Access Compliance Report

Public Rights-of-Way

(Curb Ramps)

Intersection ID: 2436	Main Street: HIGHLAND_CREEK_PY	Cross Street: CAMBRIDGE_BAY_DR	Location: W
ADA ID: 80B6E9FF6CAA	Ramp Type: PerpDiag	Initial Pass/Fail: Pass	Overall Compliance: No
Severity Score: 2.5			
Codes/Mitigation Info/Possible Solution		Field Measurements/Component Compliance

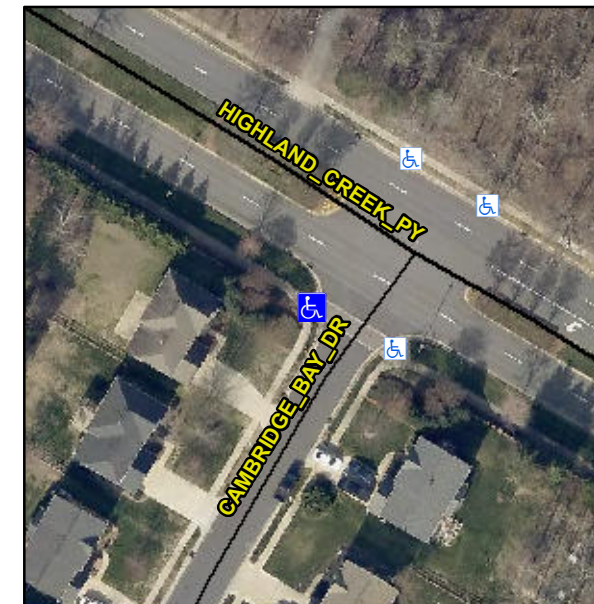
R304.2.2-Perp, R304.3.2-Para, R305.1.4, R305.2, R304.5.3

Compliance	Description	Data	Compliance	Description	Data
N/A	Ramp Length (in)	66.0	Yes	Ramp Slope (%)	6.2
Yes	Ramp Width (in)	52.0	Yes	Ramp XSlope (%)	0.1
N/A	Flare Type LT	Sloped	N/A	Flare Type RT	N/A
N/A	Flare Slope LT (%)	2.0	Yes	Flare Slope RT (%)	7.3
N/A	Flare Traversable LT?	Yes	N/A	Flare Traversable RT?	Yes
Yes	Landing Length (in)	60.0	Yes	DWS Provided?	Yes
Yes	Landing Width (in)	56.0	Yes	DWS Contrast?	Yes
No	Landing Slope (%)	3.2	Yes	DWS Length (in)	25.5
Yes	Landing X Slope (%)	1.2	No	DWS Full Width?	No
N/A	Landing Curb? (Y/N)	No	No	DWS Offset (in)	3.0
N/A	Shared Landing?	No			
Yes	Gutter Ponding?	No	Yes	Gutter Slope (%)	4.7
Yes	Gutter Lip Ht (in)	0.0	No	Gutter X Slope (%)	2.5
N/A	Painted X Walk1?	Yes	N/A	Painted X Walk2?	No
	X Walk 1 Direction	To SE		X Walk 2 Direction	To NE
N/A	X Walk 1 Width (in)	95.0	N/A	X Walk 2 Width (in)	N/A
	X Walk 1 Slope (%)	1.5		X Walk 2 Slope (%)	0.9
	X Walk 1 X Slope (%)	1.0		X Walk 2 X Slope (%)	0.4

Yes	Ramp inside XWalk1?	Yes	N/A	Ramp inside XWalk2?	N/A
	Road Slope (%)	2.9	N/A	Clear Space?	Yes
	Road X Slope (%)	1.1	N/A	Clear Space to XWalk (in)	N/A
Yes	Any Obstructions?	No	Yes	Storm Grate/Utility Hazard?	No
	Obstruction Type			Storm Grate/Utility Type	
		N/A			N/A
			Yes	Surface Condition? (G/P)	Good

Remove & Replace Curb Ramp With Two New Directional Ramps or Equivalent. Remove & Replace Gutter.
